E43-21

Proposed Change as Submitted

2021 International Building Code

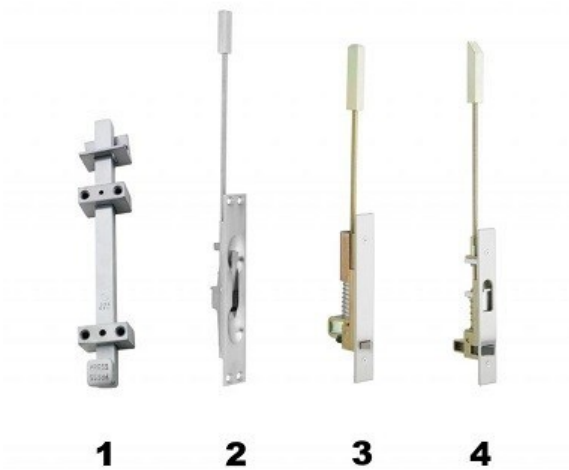
The image below illustrates two manual bolts, an automatic flush bolt, and a constant latching (flush) bolt.

1 – Manual bolt mounted on the face of the door; the bolt is operated manually.

2 – Manual bolt mounted flush on the door edge; the bolt is projected and retracted manually using a small lever.

3 – Automatic flush bolt installed on the inactive leaf, and projected automatically when the active leaf closes, and retracted when the active leaf opens.

4 – Constant-latching (flush) bolt has a self-latching bolt which is retracted manually.
